UNITED STATES PATENT AND TRADEMARK OFFICE

APPLICATION NO.	FILING DATE	FIRST NAMED INVENTOR	ATTORNEY DOCKET NO.	CONFIRMATION NO.
10/600,088	06/20/2003	Mark B. Knudson	14283.2US01	9155
7590 04/29/2005				
Merchant & Gould P.C. P.O. Box 2903 Minneapolis, MN 55402-0903				
			EXAMINER	
			MENDOZA, MICHAEL G	
			ART UNIT	PAPER NUMBER
			3731

Office Action Summary	Application No.	Applicant(s)	
	10/600,088	KNUDSON ET AL.	
	Examiner	Art Unit	
	Michael G. Mendoza	3731

Figure 3

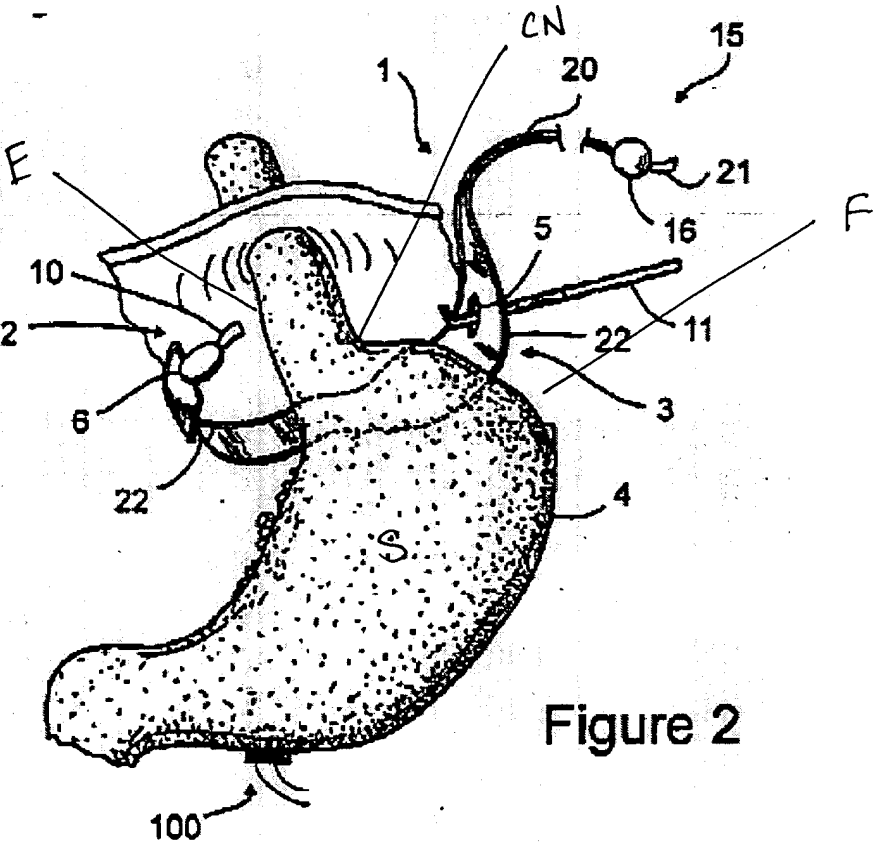
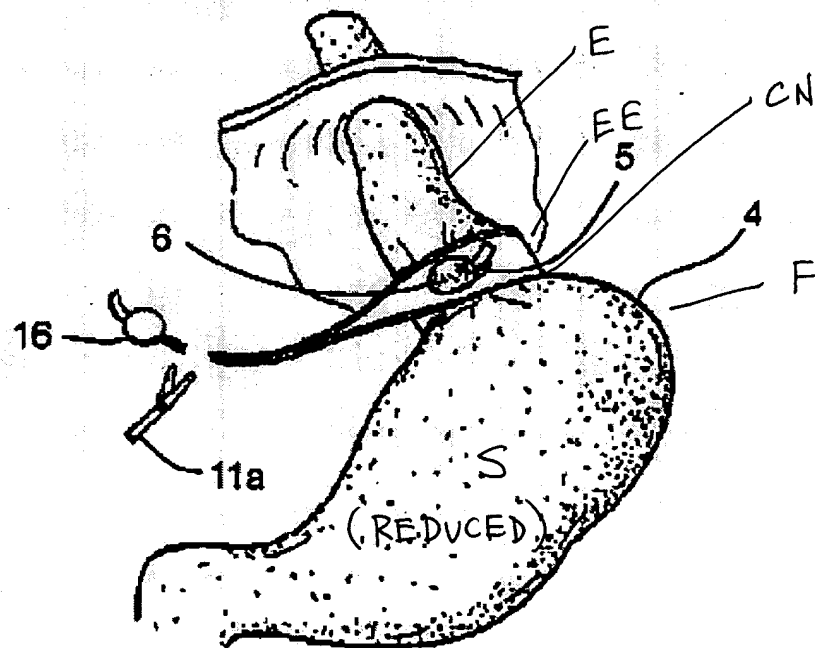
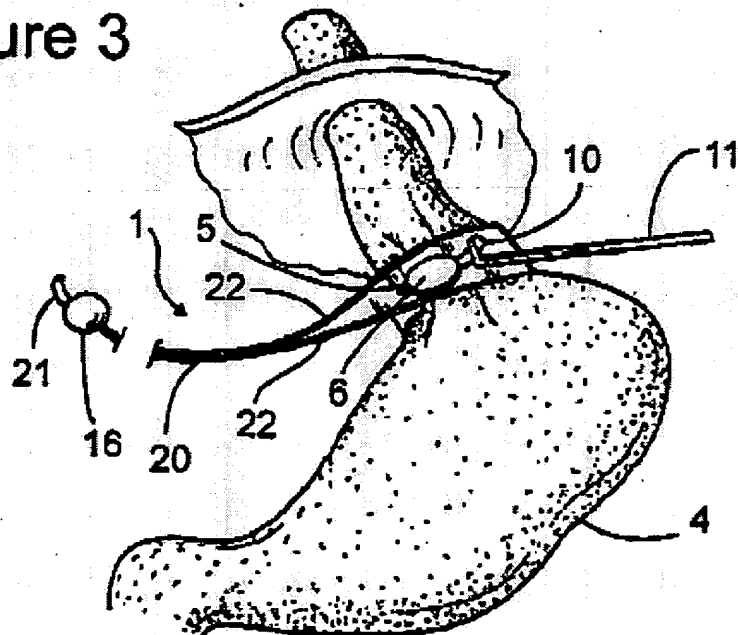
1. Applicant's arguments filed 18 January 2005 have been fully considered but they are not persuasive. The Applicant argues that the band of Cigaina is not place around the esophagus and that the band forms a pouch above the band. As shown in figures 2-4 Cigaina does teach that a band is placed around the esophagus. Cigaina does not show that a pouch is form above the band. The band is used to reduce the size of the stomach (under the band) as shown if figures 2-4.
